**TRANSBAY JOINT POWERS AUTHORITY
BOARD OF DIRECTORS**

Resolution No. 23 - 007

Addendum to the Transbay Program 2018 Final Supplemental Environmental Impact Report

December 2022

Figure 2-2. Approved BART/Muni Pedestrian Connector to be Deferred

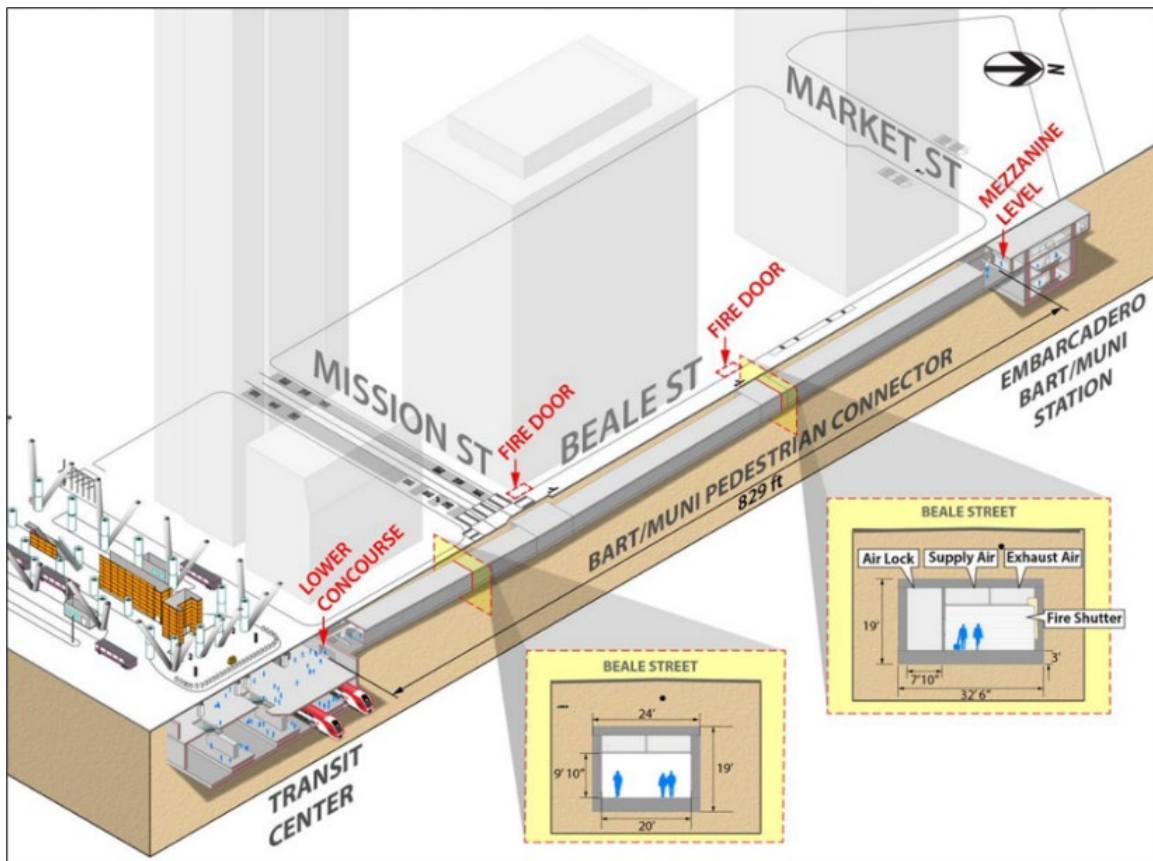
The TJPA would not construct the underground pedestrian connector analyzed in the 2018 Final SEIS/SEIR until station improvements were made at the Embarcadero BART/Muni

Metro Station and the station could accommodate the incoming passengers. Construction of the BART/Muni pedestrian connector could occur in the future and would be coordinated with BART's multi-year, phased-capacity implementation strategy and modernization concept plan for the Embarcadero and Montgomery Stations.

Description and Objective of Proposed Revision. During preparation of the 2020–2021 Transbay Program Downtown Rail Extension Phasing Study (TJPA 2021), BART staff sent a letter to the TJPA expressing no objection to the deferral of the pedestrian connector, because BART's evaluation of the Embarcadero BART/Muni Metro Station capacity was in progress. BART conducted planning work on potential options to resolve (pre-pandemic) overcrowding issues at the Embarcadero BART/Muni Metro Station, which would involve station platform modifications, and therefore would affect the approved pedestrian connector. Also, BART, in partnership with the Capitol Corridor Joint Powers Authority, has begun studying a regional rail connection from the East Bay (known as Link21) that may include a station in San Francisco to address these capacity issues. BART indicates that the studies and possible station and transbay crossing concepts will be evaluated pursuant to NEPA and CEQA approximately in the 2024–2027 timeframe. Deferral of the pedestrian connector would allow BART to develop a plan to incorporate a pedestrian connection in concert with capacity-enhancing station modifications at the Embarcadero BART/Muni Metro Station.

Figure 2-3. Proposed Reduced Train Box Extension

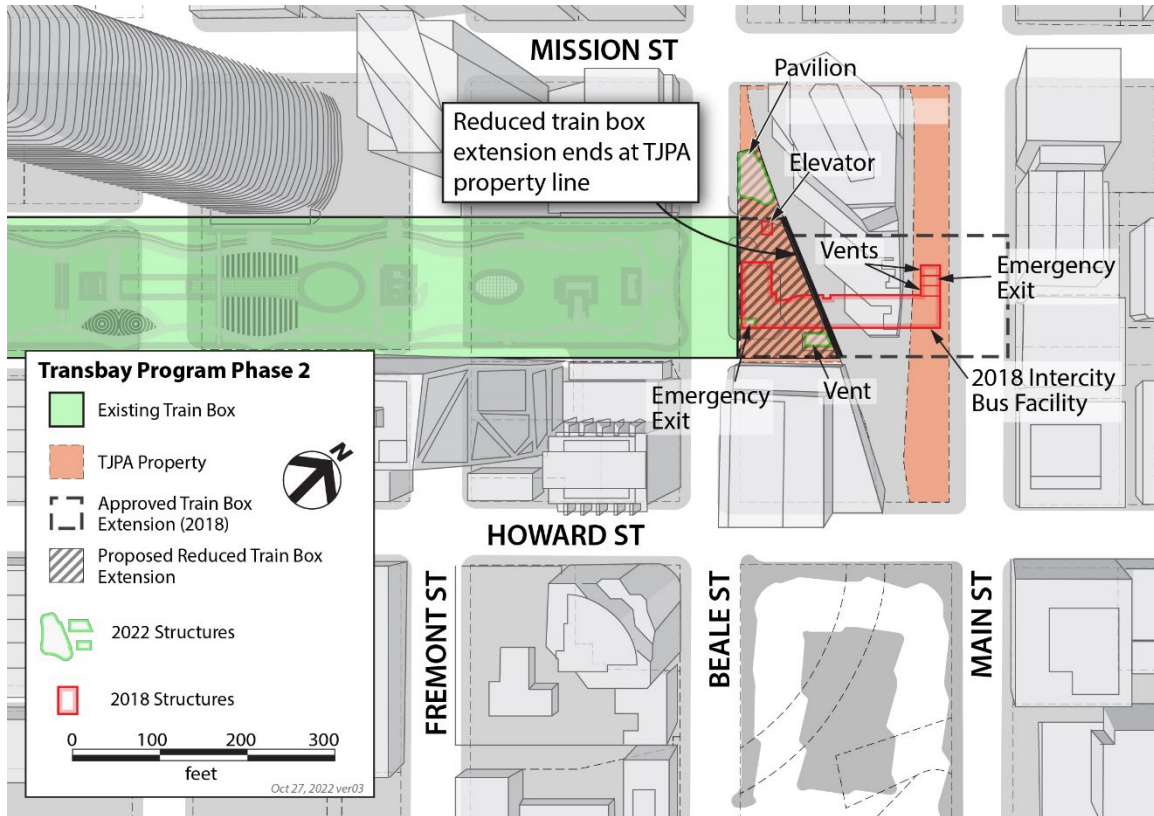
Therefore, the TJPA proposes to reduce the extension of the train box that was approved in the 2018 Final SEIS/EIR by approximately 250 feet (Figure 2-3). With this reduction, the train box extension would end at the TJPA property line just east of Beale Street. As a

result of this reduction, no land acquisition would be required for this project component, and demolition of the lower podium portion of the building at 201 Mission Street would not occur. As part of the reduction, the vent structure and emergency exit that had been approved as part of the extended train box at the Transit Center would be relocated to the TJPA parcel just east of Beale Street across from the Transit Center as shown in Figure 2-3.

Figure 2-4. Approved Intercity Bus Facility

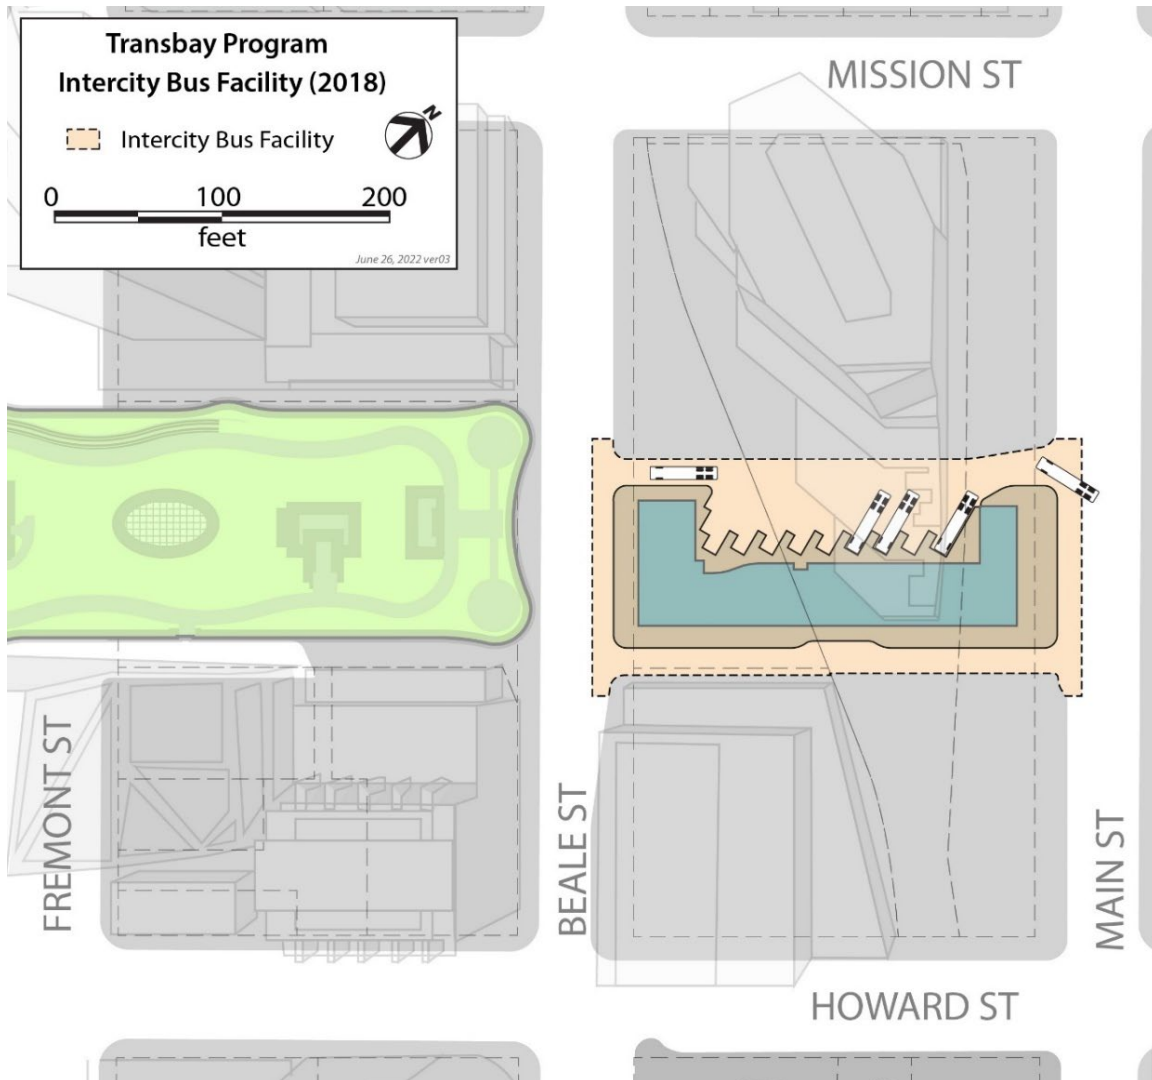
Description and Objective of Proposed Revision. AC Transit anticipates that it will need to expand its use of the bus deck between 2035 and 2050. Currently, AC Transit leases two bus bays to Greyhound, with shared use of a third bay and an additional bus bay leased to WestCAT. Greyhound has a separate lease agreement with the TJPA for approximately 4,500 square feet of the Transit Center, for its office/ticketing area, package express operations, and passenger waiting area. Both of Greyhound’s lease agreements will expire on August 31, 2029.

In addition, the approved intercity bus facility would have provided access to the Transit Center station below. With the deferral of this facility, a new street-level entrance/exit pavilion to the Transit Center would be constructed on the TJPA parcel along Beale Street, immediately north of the site for the intercity bus facility, as shown in Figure 2-3.

Figure 2-5. Approved Taxi Staging Area at the Intercity Bus Facility to be Removed

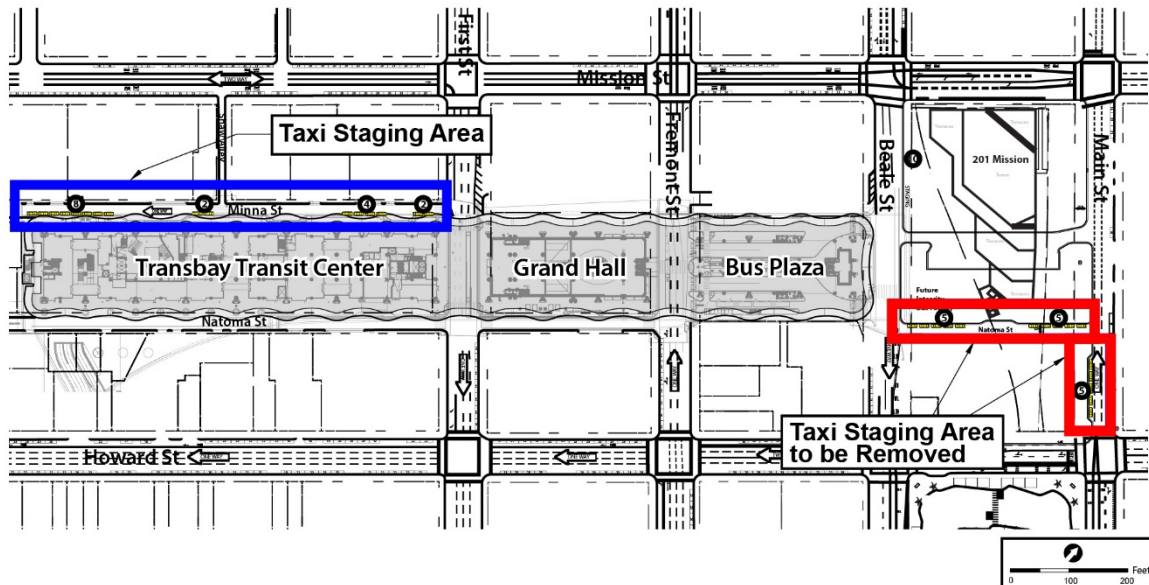
Description and Objective of Proposed Revision. Because of the deferral of the intercity bus facility and the reduced size of a future intercity bus facility as described above, no space would be available for a taxi staging area a smaller intercity bus facility. In addition, a taxi staging already is adjacent to the Grand Hall on Minna and Natoma Streets. Further, an increasing percentage of vehicle trips are performed by Transportation Network Companies that provide alternative taxi type service at designated pickup and drop off areas along Mission Street and Howard Street, around the Transit Center. Therefore, the Revised Project would remove the approved taxi staging area at the intercity bus facility.

Figure 2-6. Approved Three-Track Tunnel Segment to be Converted to Two Tracks

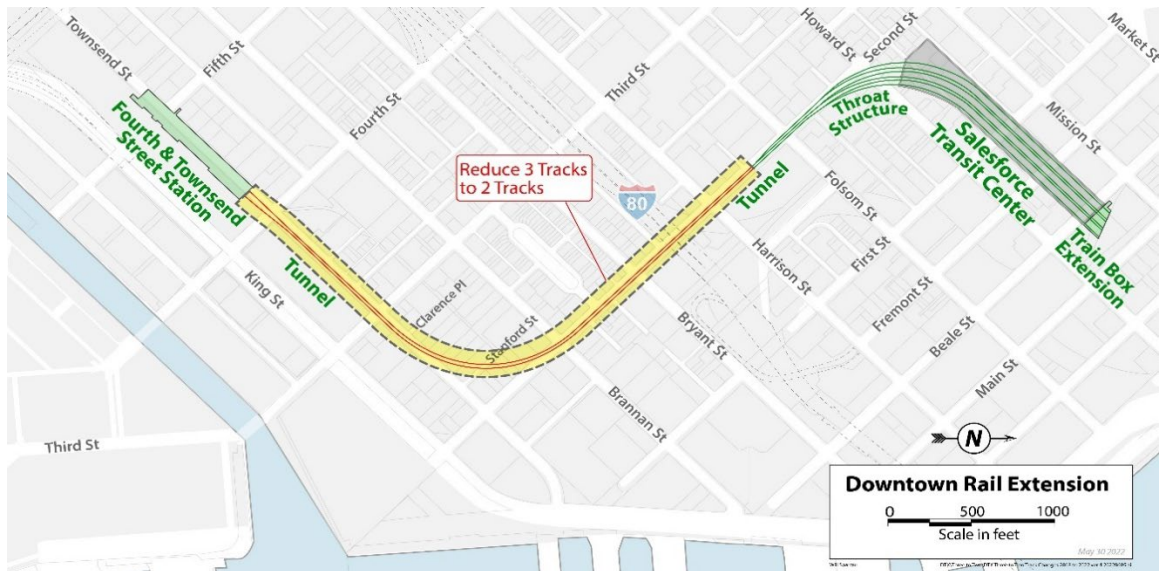
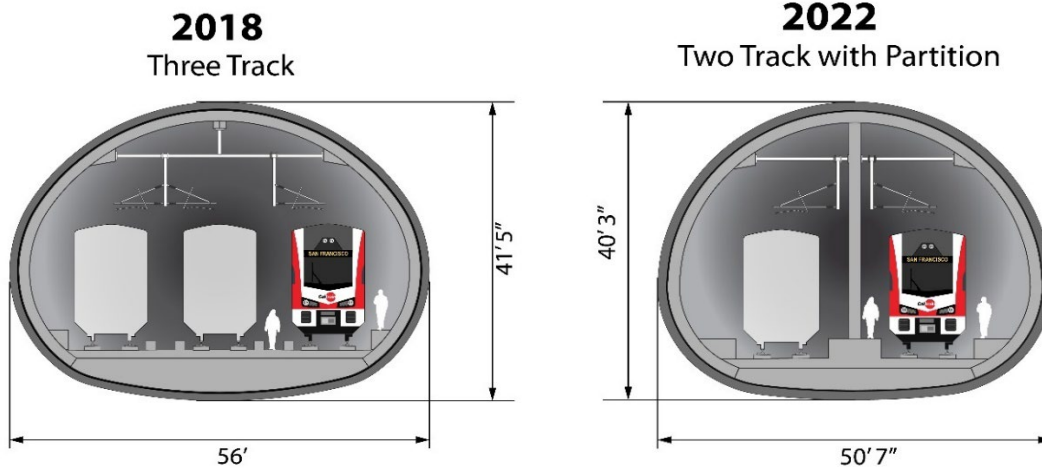
Description and Objective of Proposed Revision. An updated operations analysis was conducted as part of the phasing study analysis in 2020, conducted by Deutsche Bahn International on behalf of Caltrain and CHSRA, to validate infrastructure requirements as new information regarding the rail operators' vehicles and operating plans were defined, and to determine whether the track configuration could be optimized to enhance rail service and/or result in reduced project costs. As part of this updated operations analysis, a longer two-track section and reduced three-track section in the tunnel were recommended, together with a proposed modification of the Fourth and Townsend Street Station design (described next).

In this configuration, the three-track section of the tunnel that would be reduced to two tracks would begin mid-way between Harrison and Folsom Streets along Second Street, continue south along Second Street, and then east along Townsend Street to Fourth Street (Figure 2-6). Approximately 3,900 feet of the approved three-track configuration in the tunnel would be replaced with two tracks as part of this proposed change in design. The width of tunnel for this 3,900-foot segment would decrease from 56 feet wide to less than 51 feet wide, which also would reduce the permanent easement width in this segment (Figure 2-7). The amount of excavation also would decrease by 67,000 cubic yards because of the reduced tunnel width in this segment.

The reduced three-track segment within the tunnel would not change the throat structure that was approved in 2018. The updated operations analysis indicated that the reduced three-track segment of the tunnel would result in on-time operational performance, consistent with operators' established service standards. This reduction in the three-track section is made possible because of the improved performance of the Caltrain vehicle type and technology (i.e., electric multiple units that are self-propelled vehicles using electricity) from that previously assumed, and the modification of the Fourth and Townsend Station, as described below.

Figure 2-8. Approved Fourth and Townsend Street Station Plan and Profile to be Modified

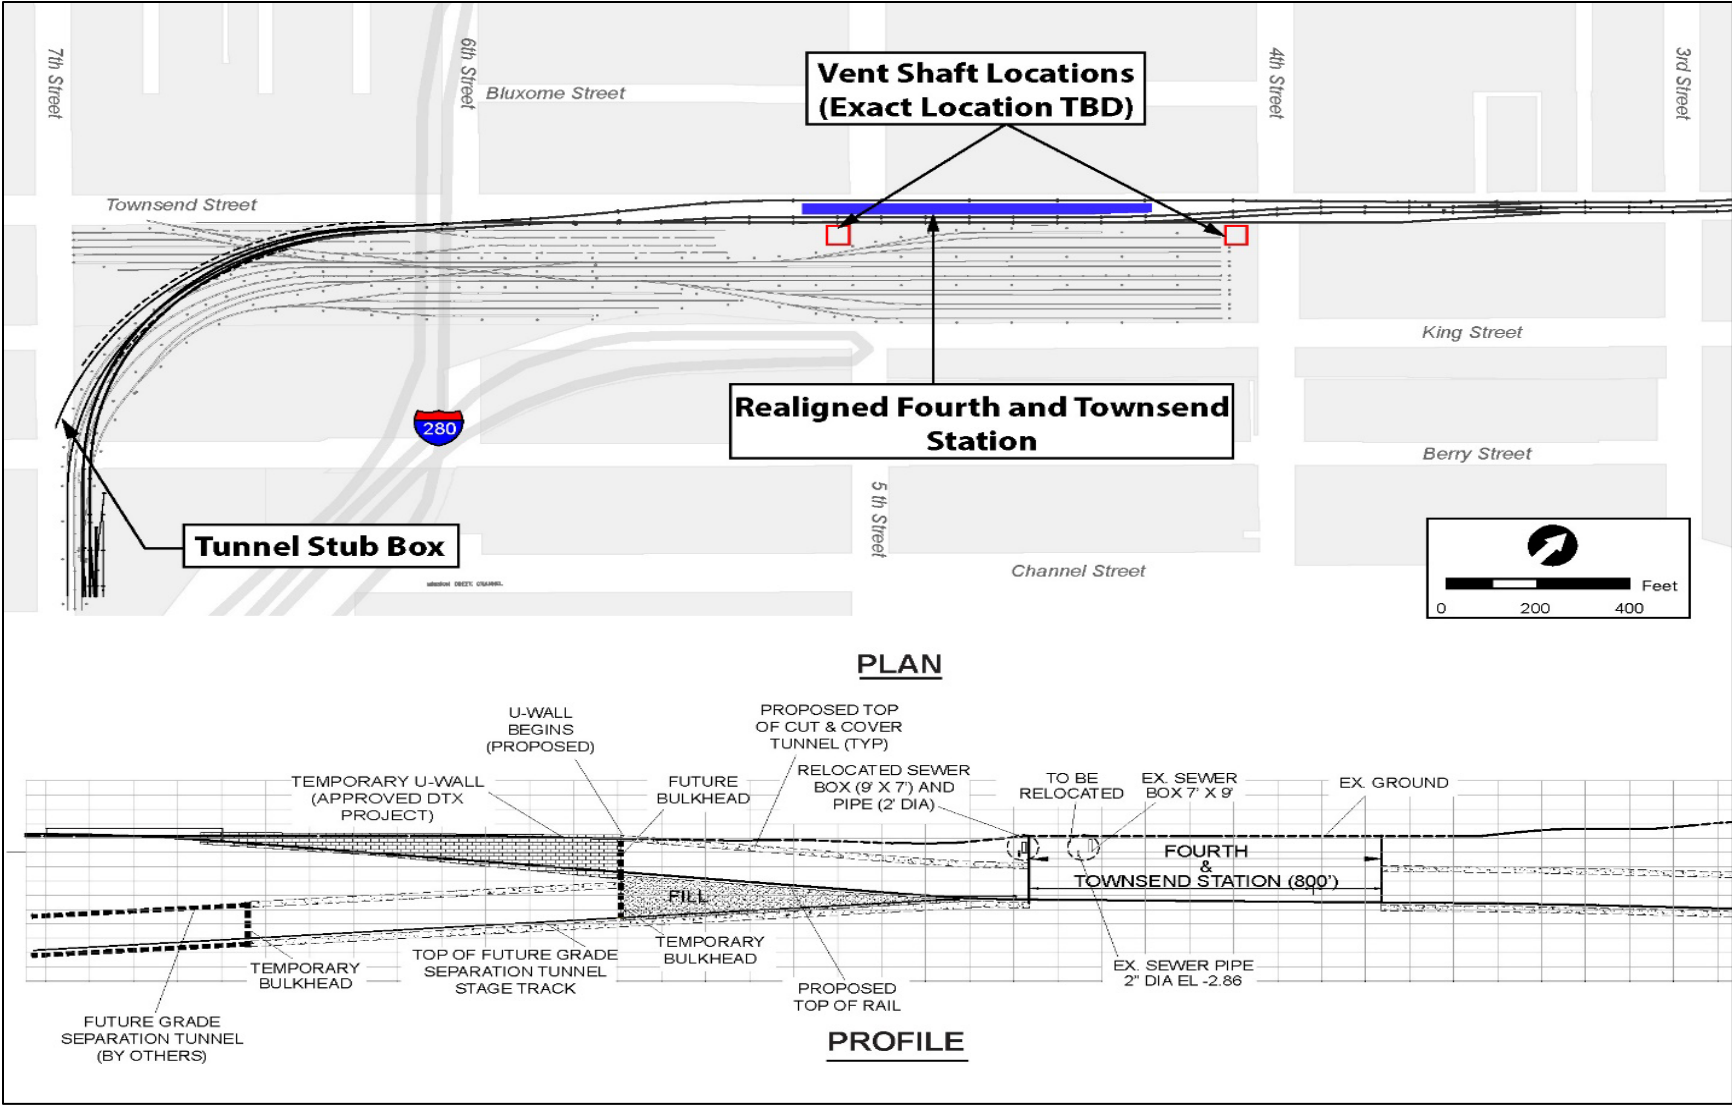
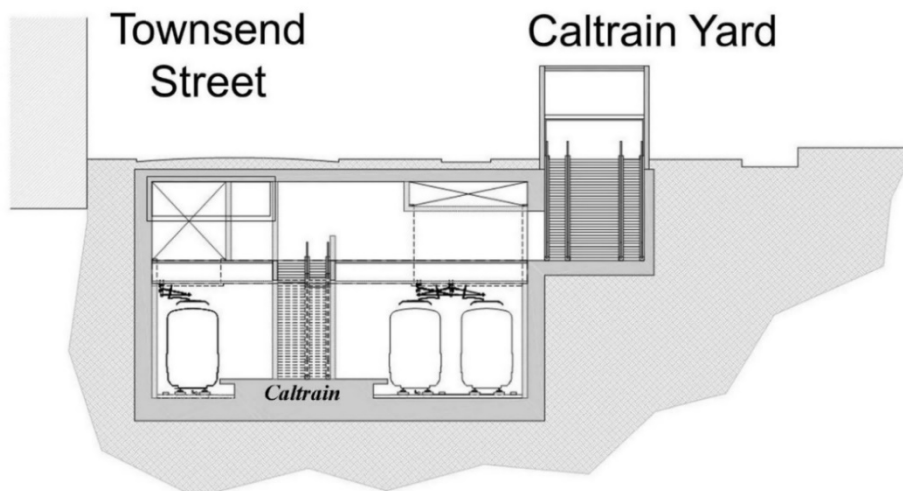
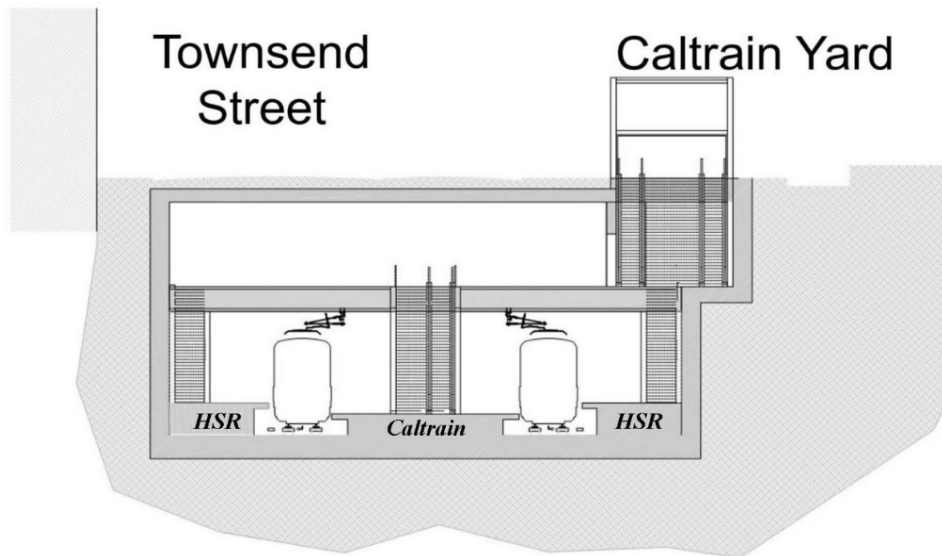
Description and Objective of Proposed Revision. CHSRA has determined that high-speed trains would stop at the Fourth and Townsend Street Station (CHSRA 2020 and 2022a). The station layout and trackwork would be modified to include two tracks serving one center platform for Caltrain passengers and two side platforms serving CHSRA passengers (Figure 2-10). The modified Fourth and Townsend Street Station design would allow service for both Caltrain and CHSRA with dedicated platforms, eliminating conflicting inbound and outbound train movements in the throat section and enabling the reduced three-track segment in the tunnel as described above. To maintain Caltrain as the regional rail service and support high-speed rail (HSR) as the intercity rail service, HSR trains would disembark passengers at the Fourth and Townsend Street Station on northbound (inbound) trips toward the Transit Center, but would not pick up passengers at the Fourth and Townsend Street Station. Northbound Caltrain riders could transfer to a southbound HSR train at the Fourth and Townsend Street Station, but would remain on Caltrain if headed north (to the Transit Center). In the opposite, southbound (outbound) direction (away from the Transit Center), HSR trains would pick up passengers at the Fourth and Townsend Street Station, but passengers would not be able to disembark. The changes to the trackwork, the addition of platforms for HSR service, and the operational analysis were reviewed and endorsed by the Integrated Program Management Team.

The addition of the platforms for high-speed trains would widen the station box, compared to the approved station. Along the 1,000-foot-long southern perimeter of the station box, certain sections would encroach approximately 4 feet further while other sections would encroach 16 feet further into the Caltrain railyard, creating a more rectangular footprint than the approved station box. The approved station design was irregularly shaped along its southern limits with the Caltrain railyard because structures for vertical circulation (i.e., stairs, escalators, elevators) and vent structures extended beyond the station train box. With this proposed change, the resulting encroachment and land acquisition would be approximately 0.29 acre more than for the approved station. The sections that would encroach approximately 4 feet further into the Caltrain railyard would be for the vertical circulation and vent structures, as shown in Figure 2-11. The 2018 approved project acknowledged that the siting of the vent structures was “to be determined” and was only generally identified. The current plans identify the vent structure sites more precisely, and the resulting shift has been conservatively analyzed as 4 feet further south than previously evaluated in the 2018 Final SEIS/EIR. The vent structure at the eastern end of the station would also be sited further to the west within the revised station footprint. The modified Fourth and Townsend Street Station, which would widen the station approximately 16 feet and lower it 4 feet (at the west end) to 11 feet (at the east end), would require an additional 50,200 cubic yards of excavation and disposal of spoil material, compared to the approved project.
